# Service Manual

CD Stereo System

**SA-AK330EE**

**Top Cabinet change (Additional Information)**
**Please file and use this supplement manual together with the service manual for Model No. [SA-AK330EE-S, Order No. MD0412591C3].**

## 2.1. Cabinet Parts Location (Additional Information)

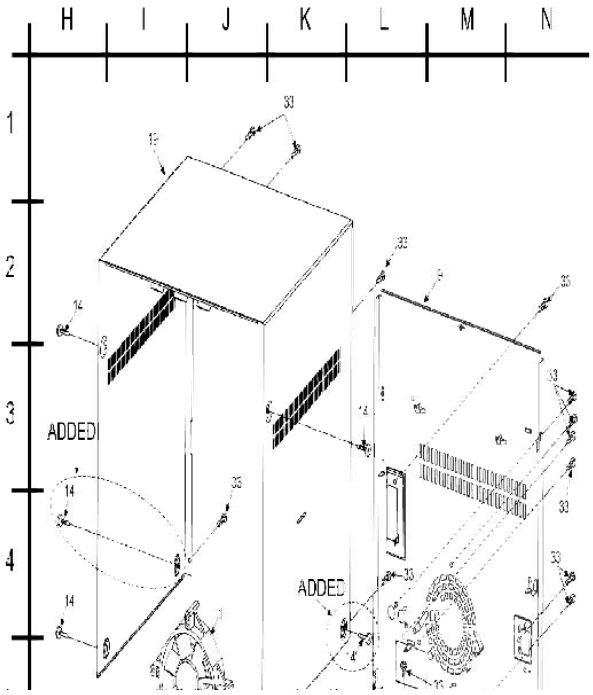
**During the replacement of the top cabinet for the mentioned models, the below rules of compatibility (Table 1) must be followed & parts must be replaced correctly. This is mainly due to top cabinet specification change (additional of one screw hole) for improvements.**

**With reference to page 97 (section 22.3.1) of the original service manual for SA-AK330EE-S. The cabinet parts location below is for the new implementation.**

**- When replacing the new top cabinet, ensure that the NEW bottom**

**chassis must also be changed together at the same time (Refer to Table 1).**

**- Do not interchange the parts.**
